## STAFF RECOMMENDATION 309 Manchester Avenue September 16, 2015

**Application:** New construction--infill  
**District:** Eastwood Neighborhood Conservation Zoning Overlay  
**Council District:** 06  
**Map and Parcel Number:** 08302030300  
**Applicant:** John Root  
**Project Lead:** Paul Hoffman, paul.hoffman@nashville.gov

<p><b>Description of Project:</b> Infill of a single-family residence.</p> <p><b>Recommendation Summary:</b> Staff recommends approval with the conditions:</p> <ol style="list-style-type: none"> <li>1. A window opening is added to the building's right side on the first floor;</li> <li>2. The finished floor height shall be consistent with the finished floor heights of the adjacent historic houses, to be verified by MHZC staff in the field;</li> <li>3. Staff approve the final details, dimensions and materials of windows and doors prior to purchase and installation; and,</li> <li>4. The HVAC shall be located behind the house or on either side, beyond the mid-point of the house.</li> </ol> <p>Staff finds the application meets the design guidelines for the Eastwood Neighborhood Conservation Zoning Overlay.</p>	<p><b>Attachments</b></p> <p><b>A:</b> Photographs <

Figure 3. Right elevation. Staff recommends adding a window in at least one of the locations marked.

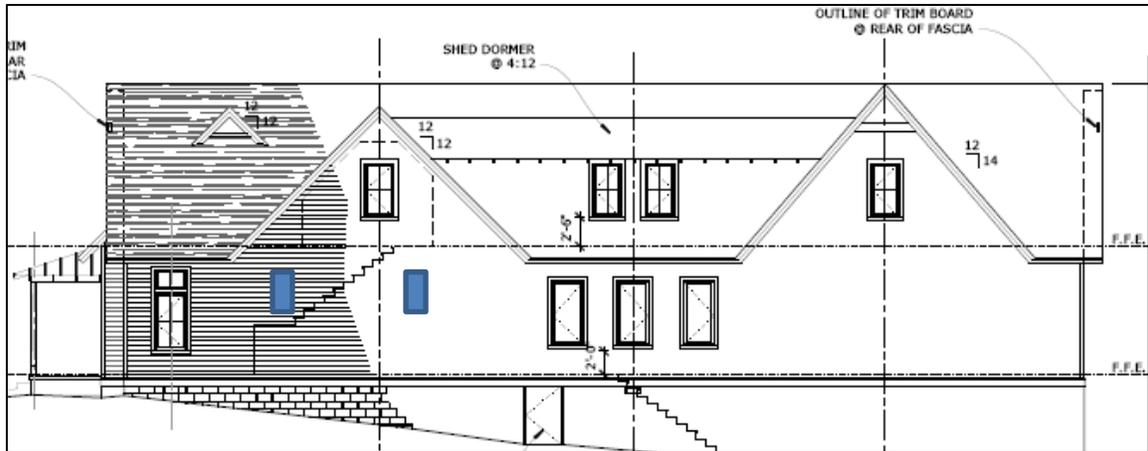
Proportion and Rhythm of Openings: The proposed windows are generally twice as tall as they are wide, meeting the historic proportions of openings. There is one large expanse of more than thirty feet (30') wall space on the building's right side without a window or door opening (Figure 3). Staff's recommendation is that at least one opening be added to this area. With this condition, Staff finds the project's proportion and rhythm of openings to meet Section II.B.1.g.

1. A window opening is added to the building's right side on the first floor;
2. The finished floor height shall be consistent with the finished floor heights of the adjacent historic houses, to be verified by MHZC staff in the field;
3. Staff approve the final details, dimensions and materials of windows and doors prior to purchase and installation; and,
4. The HVAC shall be located behind the house or on either side, beyond the mid-point of the house.
